## FORD: 2003 MUSTANG

## ISSUE

Article No. 03-3-6 Cont'd.

Figure 1 - Article 03-3-6

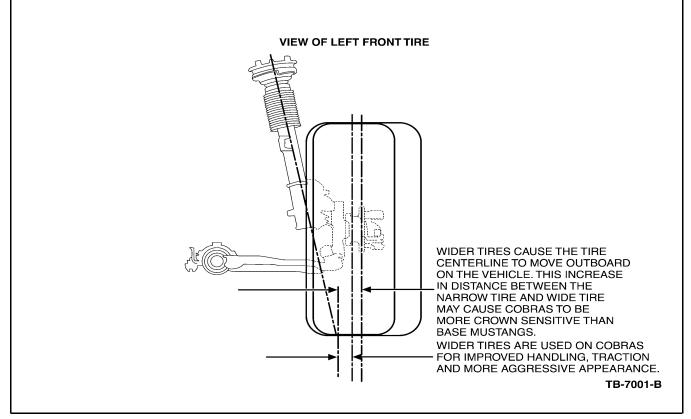
Wider tires cause the tire centerline to move outboard on the vehicle (Figure 1). This increase in distance between the narrow tire and the wide tire may cause Cobra models to be more crown sensitive than base Mustangs. Wider tires are used on the Cobra to meet the expectations for driving dynamics and more aggressive appearance.

- Inspect front tires for condition and pressure. Adjust pressure to 32 psi and rotate tires if necessary.
- 2. Inspect front suspension components (bushings, ball joints, wheel bearings, shocks, etc.) for wear or play and replace as necessary.
- 3. Inspect steering components (tie rod ends, intermediate shaft, steering gear) for wear or play and replace if necessary.
- 4. Inspect brakes for brake drag and replace if necessary.
- 5. Realign vehicle to revised specifications below.

2003 MUSTANG COBRA ALIGNMENT SPECIFICATIONS				
ltem	Unit	Left	Right	Total/Split
Front Camber Front Caster Front Toe-In Rear Camber Rear Toe-In	Degrees Degrees Degrees Degrees Degrees	$\begin{array}{c} -0.8 \pm 0.2 \\ 3.1 \pm 0.2 \\ 0.125 \pm 0.04 \\ -0.8 \pm 0.2 \\ 0.10 \pm 0.04 \end{array}$	$-1.0 \pm 0.2$ $3.3 \pm 0.2$ $0.125 \pm 0.04$ $-0.8 \pm 0.2$ $0.10 \pm 0.04$	$\begin{array}{c} +0.2 \pm 0.2 \\ -0.2 \pm 0.2 \\ 0.25 \pm 0.08 \\ 0.0 \pm 0.2 \\ 0.20 \pm 0.08 \end{array}$
